# Access Compliance Report

## Public Rights-of-Way

### (Curb Ramps)

Intersection ID: N/A	Main Street: PROVIDENCE COUNTRY CLUB DR	Cross Street: WAVERLY WALK AV	Location: SW
ADA ID: B2FB218DD615	Ramp Type: Directional	Initial Pass/Fail: Fail	Overall Compliance: No
Severity Score: 13.75			
Codes/Mitigation Info/Possible Solution		Field Measurements/Component Compliance

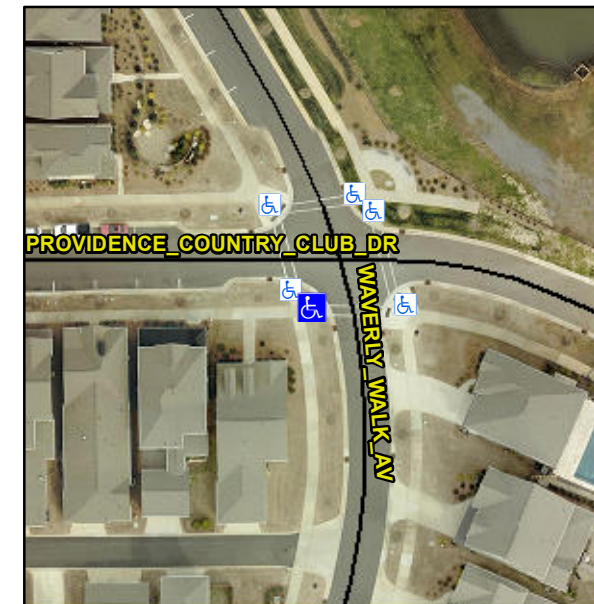
**Remove & Replace Entire Ramp.**

**R304.2.2, R304.5.3**
